Field campaign

Topic	Mulsanne side view camera control module (SC12/15)
Market area	Worldwide Bentley (1WBE)
Brand	Bentley
Transaction No.	2030874/2
Campaign number	E775
Note	
Type	
US code

Mulsanne

Figure 1

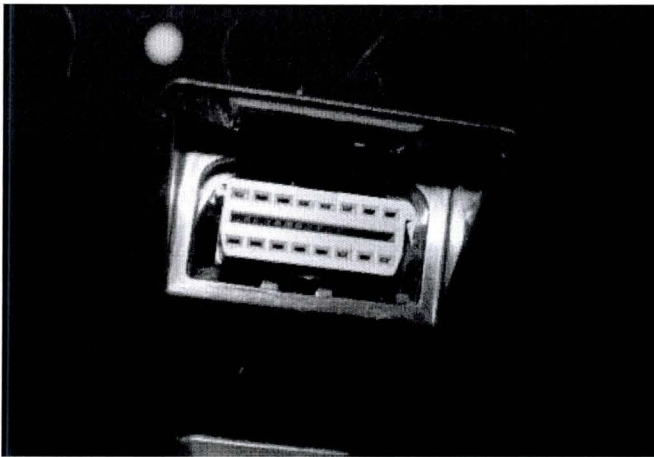
In January 2012 a TPI was released which instructed Dealers to remove where fitted the side view camera control module as a potential fault was identified with the original part. The latest specification side view camera control module is now available for all Bentley Mulsanne vehicles which were specified with the side view camera option. If the original module has been previously removed and replaced with the link loom as per previous instruction, a Yellow paint mark will be evident on the diagnostic plug surrounding cover as shown in Figure 1, please remove the loom and fit the replacement side view camera module as detailed within this document.

Should the vehicle still have the original side view camera module fitted or the link loom was installed at the time of production a Yellow paint mark will not be evident, if this is the case please replace the existing module or remove the link loom and replace with the latest specification part as detailed within this document.

Figure 1

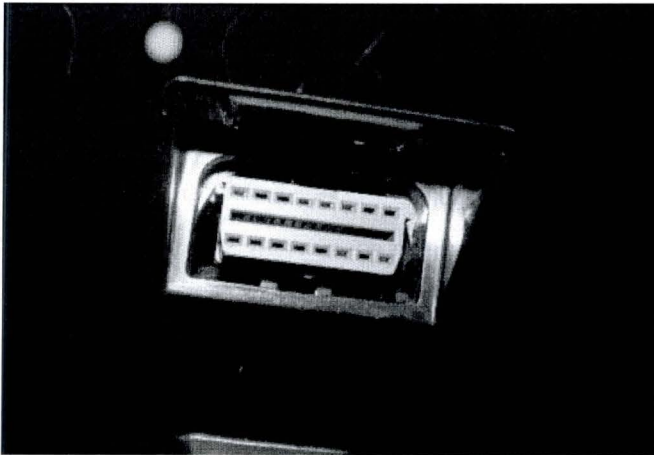
In January 2012 a TPI was released which instructed Dealers to remove where fitted the side view camera control module as a potential fault was identified with the original part. The latest specification side view camera control module is now available for all Bentley Mulsanne vehicles which were specified with the side view camera option. If the original module has been previously removed and replaced with the link loom as per previous instruction, a Yellow paint mark will be evident on the diagnostic plug surrounding cover as shown in Figure 1, please remove the loom and fit the replacement side view camera module as detailed within this document.

Should the vehicle still have the original side view camera module fitted or the link loom was installed at the time of production a Yellow paint mark will not be evident, if this is the case please replace the existing module or remove the link loom and replace with the latest specification part as detailed within this document.

3. Should the original side view camera control module have been previously removed and replaced with the link loom 3Y0 998 381 there should be a Yellow completion paint mark on the diagnostic plug surrounding cover (Figure 1), please carefully remove this and replace with a White paint completion mark as shown in Figure 2. If the original control module has been replaced for the latest specification part or the factory fitted loom has been replaced with the latest specification part, a White paint completion mark should also be added (Figure 2)
